PLANNING COMMISSION MEETING AGENDA

4. ***Continued from February 28, 2024 - P23-0177, Bruce Myers, Catalyst Development Partners LLC, Tract 8672, 3200 Hopyard Road*** – Applications for Design Review (P23-0177) and Vesting Tentative Tract Map 8672 approval pursuant to SB 330 to: 1) demolish an existing church and daycare facility; 2) construct a housing development consisting of 57 attached condominium units including 48 three-story townhomes ranging in size from approximately 1,691 to 2,738 square feet, and nine apartment units; and related site improvements; and 3) Vesting Tentative Map.

3200 HOPYARD ROAD
TENTATIVE TRACT MAP NO. 8672
COVER SHEET

Figure 9: Excerpt of Vesting Tentative Track Map Exhibit C8 (May 2023)

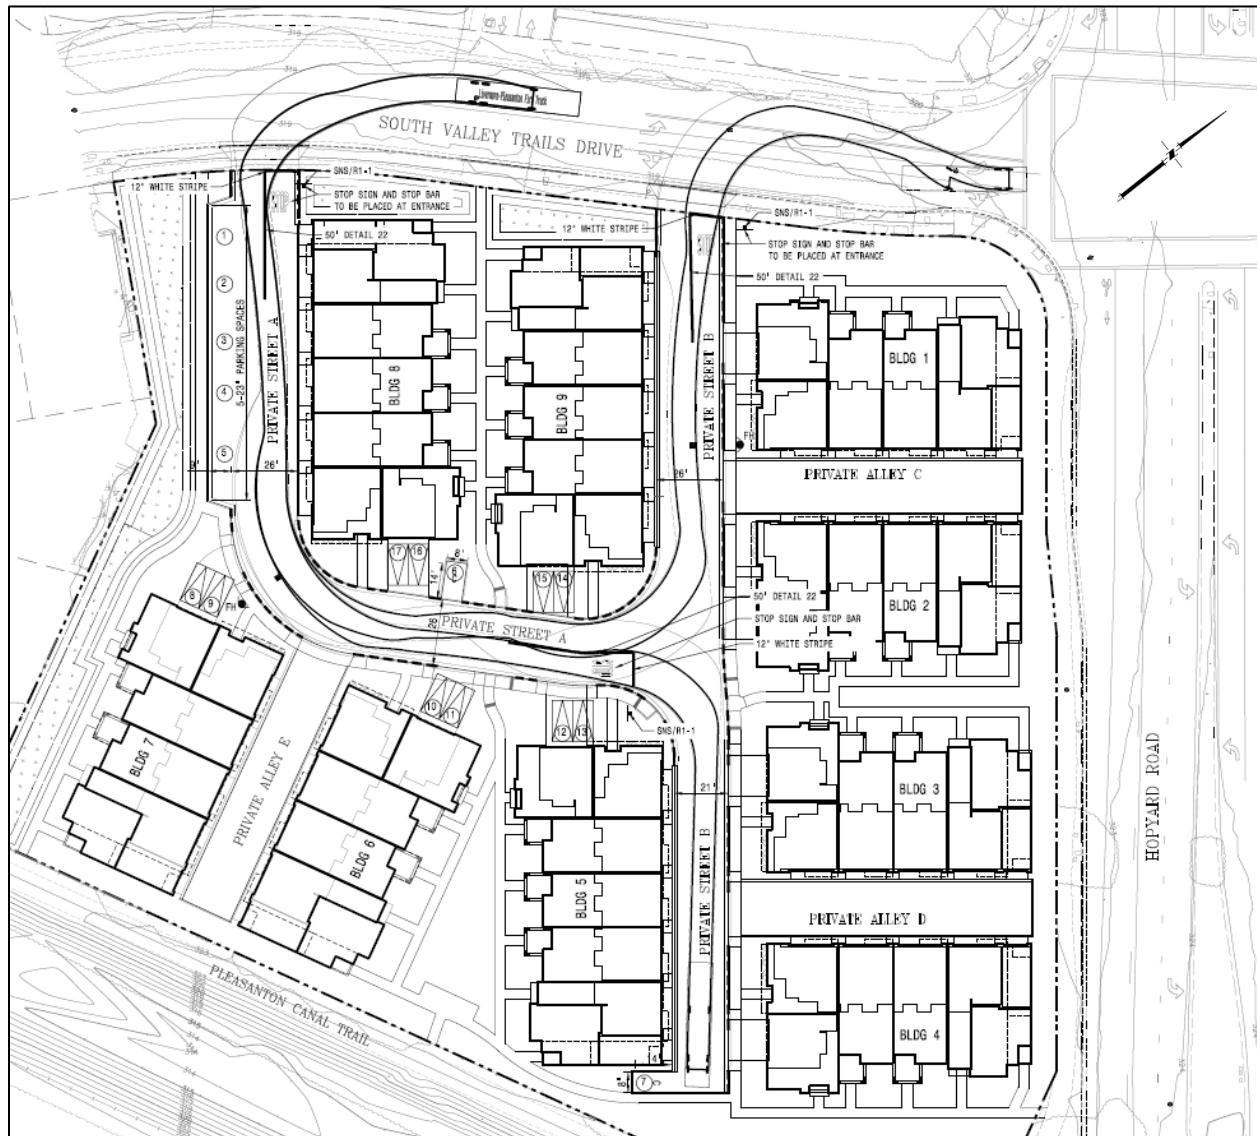
As shown in **Figure 9**, the site is served by two private streets that each connect with South Valley Trails Drive. These roads vary from 21 to 26 feet in width. Three private alleys provide additional access to six of the nine residential buildings. TJKM expects that this internal roadway configuration would adequately service the site.
